1.1.2 The Proposed Development description for the outline planning application, planning reference: 21/01630/OUT, is as follows:

1.1.4 This response has been prepared to address the four reasons for objection raised by OCC in their latest consultation response, as well as to provide additional information relative to highway matters.

TECHNICAL NOTE: RESPONSE TO OCC COMMENTS

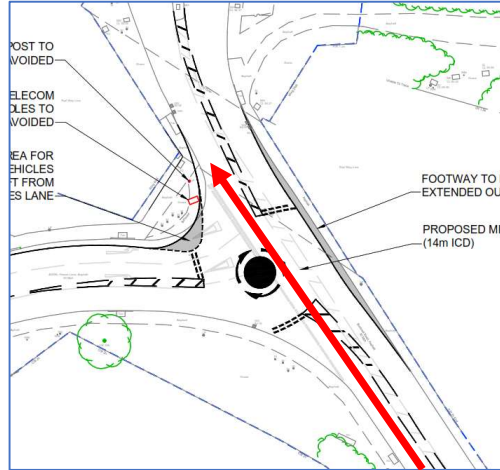
The realigned kerb of the northern exit arm of Bucknell Road, produces a reduced footway width on the western side of the road. The design sketch appears to show a footway width of approximately 1m. The reduced footway width may lead to pedestrians walking in the carriageway to pass others on the footway. This may lead to pedestrian to vehicle collisions. This may be exacerbated by the restricted inter-visibility between opposing pedestrians at this location, due to the railway bridge wing wall.

The reduced footway width may bring pedestrians closer to the carriageway edge, and the wing mirrors of large vehicles may overhang the footway resulting in wing mirror strikes to pedestrians.

It is recommended that measures are introduced to provide a footway width that enables opposing users to pass without entering carriageway areas; measures may include the realignment of kerb lines.

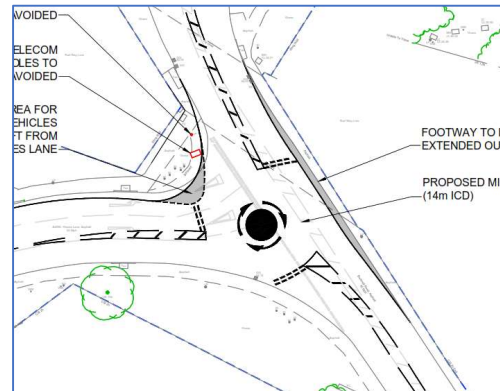
The offset central island location produces an excessive vehicle path through the junction for northbound users. This may lead to drivers failing to appropriately 'negotiate' the central island. Poor compliance with the circulatory requirements of the junction may lead to vehicle to vehicle collisions.

It is recommended that the size and location of the central island is amended to encourage appropriate circulatory movements for all turning manoeuvres. Measures may include a reduction in central island diameter, realignment of the eastern kerb realignment and a reduction of the circulatory carriageway width.

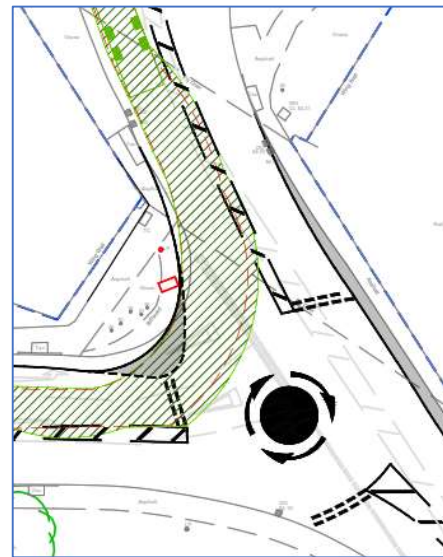
On the northern, Bucknell Road entry, drivers may fail to appreciate the presence of the mini roundabout, as siting of the diag 611.1 sign may be problematic and there may be reduced forward visibility to the sign. Poor perception of the change junction arrangements may lead to failure to give way or late braking shunt type collisions.

It is recommended that forward visibility to the diag 611.1 sign is maximised to provide adequate warning of the junction type. Existing map type direction signs for the conventional roundabout on the A4095 (E) and Bucknell Road (N) approaches should be amended to clearly identify the new roundabout junction at Howes Lane.

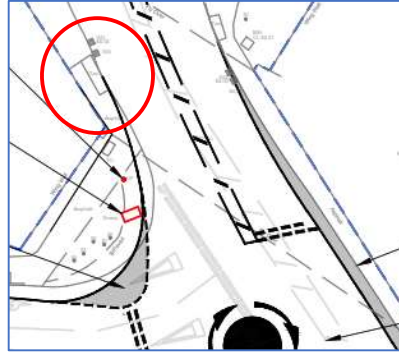
Whilst on site, the audit team noted that the drivers of large vehicles over-ran the central hatched area and opposing traffic lane when making a left turn manoeuvre from Howes Lane on to Bucknell Road. The swept path drawings provided indicate that drivers of large vehicles may have to carry out a precise left turn manoeuvre to avoid over-running the opposing traffic lane or striking nearside kerbs. This manoeuvre may lead to vehicle to vehicle collisions with the introduction of the mini roundabout and revised kerb line of the eastern side of Bucknell Road.

It is recommended that measures should be introduced to minimise the likelihood of large vehicle swept paths crossing the hatched areas and entering the opposing traffic lane; measures may include widening the hatched markings separating the two traffic streams, reducing the southbound traffic lane width, and amending the eastern kerb line.
